August 26, 2016

re: File # 14-0656, CPC-2015-3484-CA & ENV-2015-4197-EAF

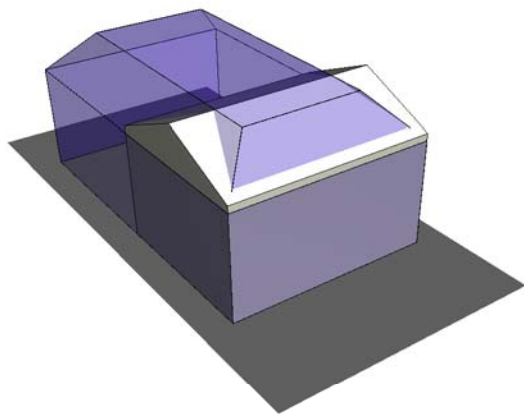
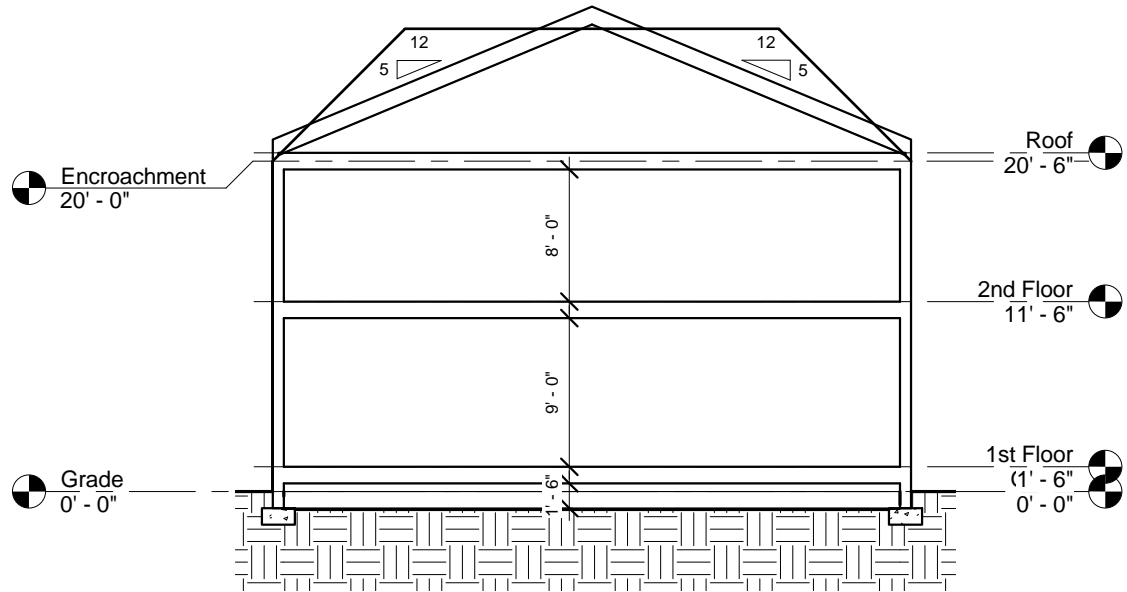
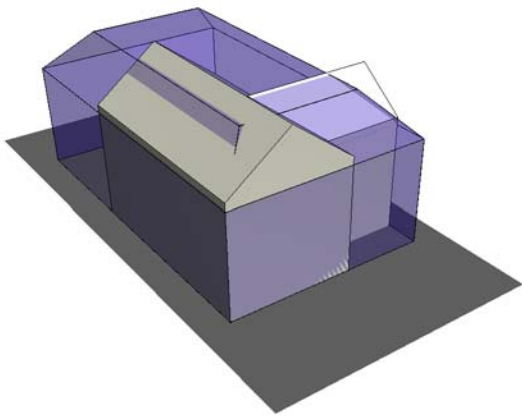
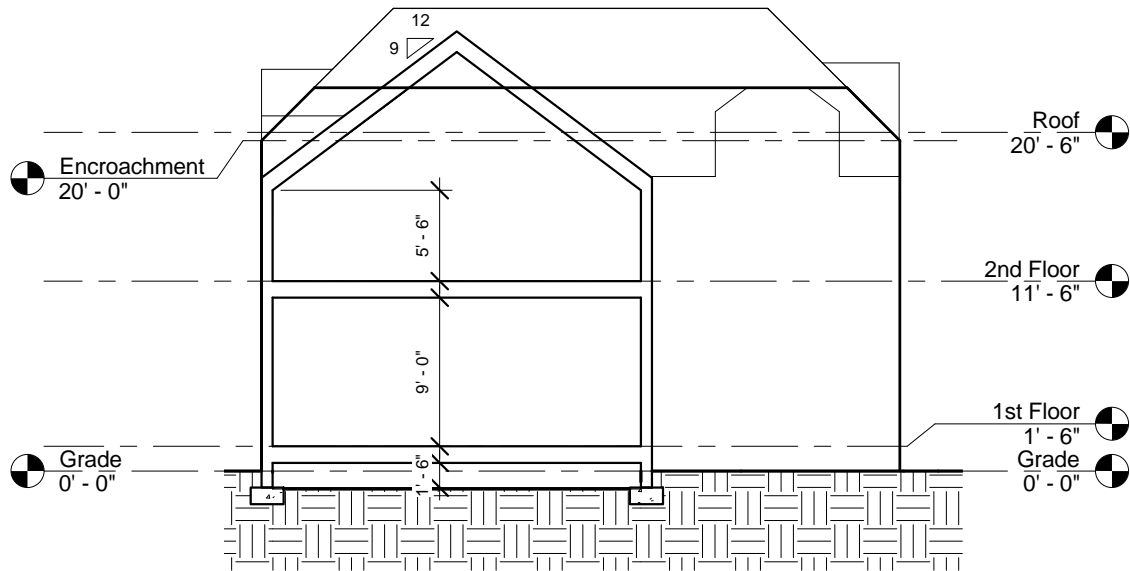
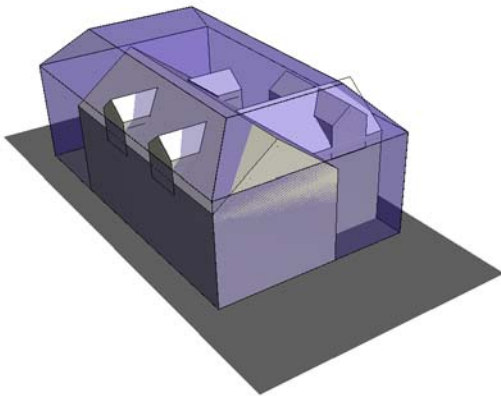
No allowance for even limited protrusion through the sloped planes of the encroachment plane is extremely detrimental to stylistic variety and excellence in design. Attached diagrams 1 – 4 illustrate but a few examples using a 50' wide lot.

A two-story Colonial style home design (with a ridge parallel to the street) would not be possible on a 50' wide lot without such accommodation unless the home width is reduced by 16' to a mere 24' wide with 13' side yards. The designs of Craftsman, Victorian or Cape Cod style homes where side gables and dormers are predominant would be severely hampered to the point of encouraging bad design. And when attempting to lower the roof top plate to avoid the maximum height, useable spaces are not possible without dormers the encroachment plane precludes. Even the design of flat-roofed contemporary homes (which the "preservation" bent of this change seem to be directed to discourage) would be negatively affected on the typical 50' and narrower lots forcing completely and consistently symmetrical "wedding cake" designs for a reasonable width second story.

Allowance for limited protrusions through the sloped planes would allow for greater variety in design, asymmetries and details on which design excellence of most home design depends. Such accommodation would also not significantly impact the light and space intent of the sloped planes, especially with more traditional designs. Pacific Palisades Tract 9300 has developed language to accommodate just such an allowance and I recommend similar allowances be incorporated into this revision.

① Section 2  
1/8" = 1'-0"

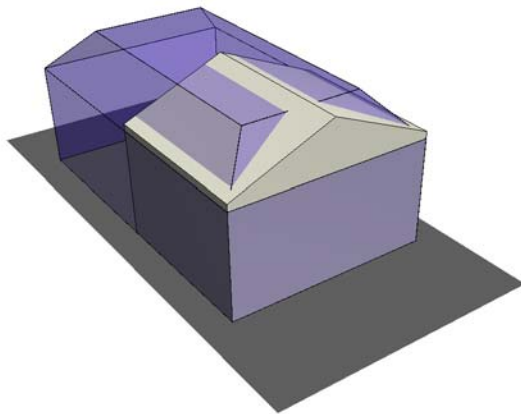
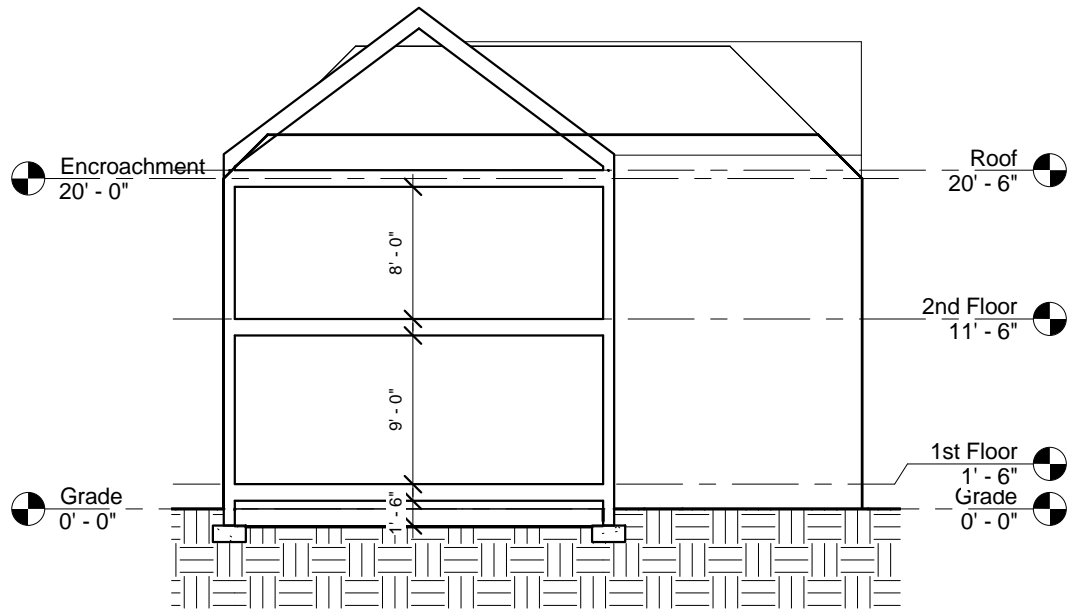
20' encroachment plane height is insufficient to allow a typical 2-story construction on raised floor foundation (most all of LA's existing R1 fabric) with side walls on the setback line (see diagram 2 section.) This amounts to a default increase in setback for two story structures on all proposed zones (except R1V1). Such increase becomes excessively restrictive on 50' or narrower lots, and then particularly so on those with existing homes with raised floors and a foundation line on or near the standard yard setback.. Most existing homes faced with this increased setback for a second story typically would incur significant added costs for a new foundation line within the existing finished structure. 22' is a more reasonable encroachment plane height to allow full-height second-story additions to existing structures.
